Date: October 9, 2002
 To: T10 Technical Committee
 From: Alvin Cox (alvin.cox@seagate.com)
 Subject: SAS Test Loads

The following changes to text and test load figure are made to aid the testing process by clarifying and defining the compliance channel test load and zero-length test load.

Figure 33 — Test loads

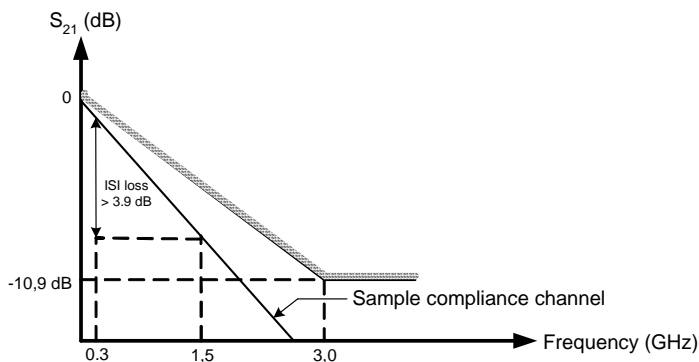
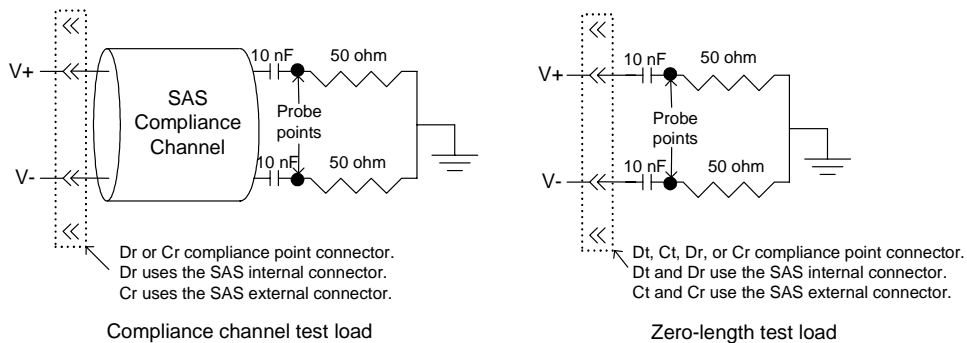
The driver shall have the output voltages and timing listed in table 17 and table 19 measured at the designated interoperability points. The default point is Ct for inter-cabinet TxRx connections and Dt for intra-cabinet TxRx connections. The measurements shall be made across a load equivalent to **the zero-length load that** shown in figure 33 **unless otherwise specified**.

A compliance channel magnitude response and ISI loss example for 3 Gbps is shown in figure 33.

$$|S_{21}| \leq -20 \log(e) \{ [6.5 \times 10^{-6} (f^{-5})] + [2.0 \times 10^{-10} (f)] + [3.3 \times 10^{-20} (f^2)] \} \text{ dB}$$
